©Kawasaki Motors Corp 1974 Printed in USA

PROBLEM:

An early H1 may start losing power, misfiring, backfiring, or stop running altogether. Installation of new spark plugs seems to clear up the problem, leaving the impression that the used plugs were defective. However, the problem returns after a short period of use with the new spark plugs.

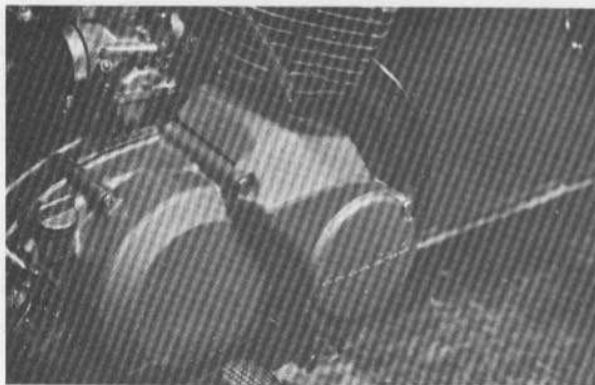
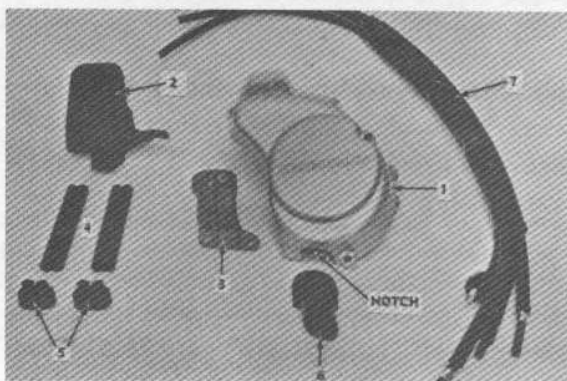
The spark plugs generally are not the cause of the problem. We have found the high tension wiring leaks electricity to adjoining metal engine parts under high voltage loads. New spark plugs require less voltage to fire because the electrodes have sharp edges. As the plugs are used, these sharp edges are rounded off by high energy discharge and erosion from heat and chemical action in the combustion chamber. Consequently, they require an increasing amount of voltage to fire as mileage accumulates. Worn spark plugs, over-rich oil pump settings, or incorrect fuel mixtures demand more voltage from the ignition system to fire the spark plugs. These conditions "back up" the voltage in the secondary wiring until it jumps through the H.T. cord insulation to an inviting engine ground rather than fire the plugs.

KAWASAKI has developed a set of high tension components which, after thorough testing, has proven completely reliable and eliminates the insulation leakage problem. The purpose of the new components is to re-route the H.T. cords so they are a safe distance from metal engine grounds like the oil pump, oil pump cover, engine cover, cylinders, carburetors, etc. Additionally, the type of H.T. cord has been changed from DAIICHI brand to Belden, a better-insulated cable.

EARLY H.T. WIRING

LATE H.T. WIRING

H1 with original H.T. wiring

H1 with new H.T. wiring kit
(P/N 99990-015)

NOTE: Watch the following items when installing the new parts.

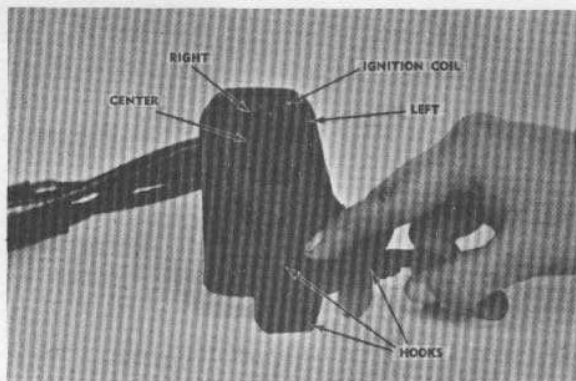
Use Rubber band P/N 92072-013 to fix loom to right frame tube under gas tank.

To save time, use the photo above for inserting the cords in the grommet. The bottom cords should protrude 1" more than the top ones.

To keep water from entering, make sure the bottom of the grommet is hooked onto the crankcase. Route the H.T. cords over the RH carburetor, NOT between the carburetor and cylinder.

Jam the H.T. cords completely into the distributor cap sockets before installing the piercing screws.
